To: Shane Lippard, P.E.
From: Pat O’Mahony, Associate Planner; 910-341-0189
CC: File;
Date: 8/13/2021
Re: Bug N A Rug TRC rev. 3

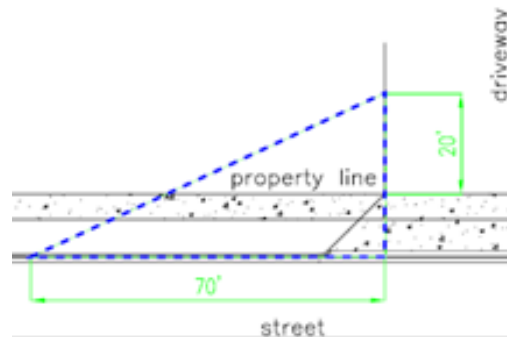
1. City’s 20’x70’ sight distance triangle shall be applied as per below image. [Sec.18-529(c) (3) CofW LDC] [Sec. 18-812 CofW LDC].
